TECHNICAL BULLETIN

No: LTB00202
Issue: 1
Date: 09 FEB 2009

Navigation System Routing Errors - Repair Procedure

Figure 3

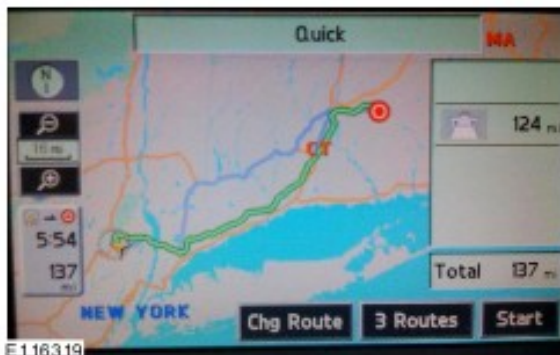
3. Navigation system does not display city entered. (Figure 3)
4. City entered displayed / route as expected. (Figure 4)

1. Switch ignition 'ON'.
2. Remove Navigation system DVD.
3. Verify DVD part number:
 - If the DVD part number is 6H42-10E898-BB, continue to step 4.
 - If the DVD part number is not 6H42-10E898-BB, verify the Navigation system routing preferences / settings and contact the Land Rover Technical HelpLine if necessary.

4. Install new Navigation DVD, allowing the Navigation module to update.
5. Once the Navigation system displays the disclaimer screen, switch the ignition 'OFF'.
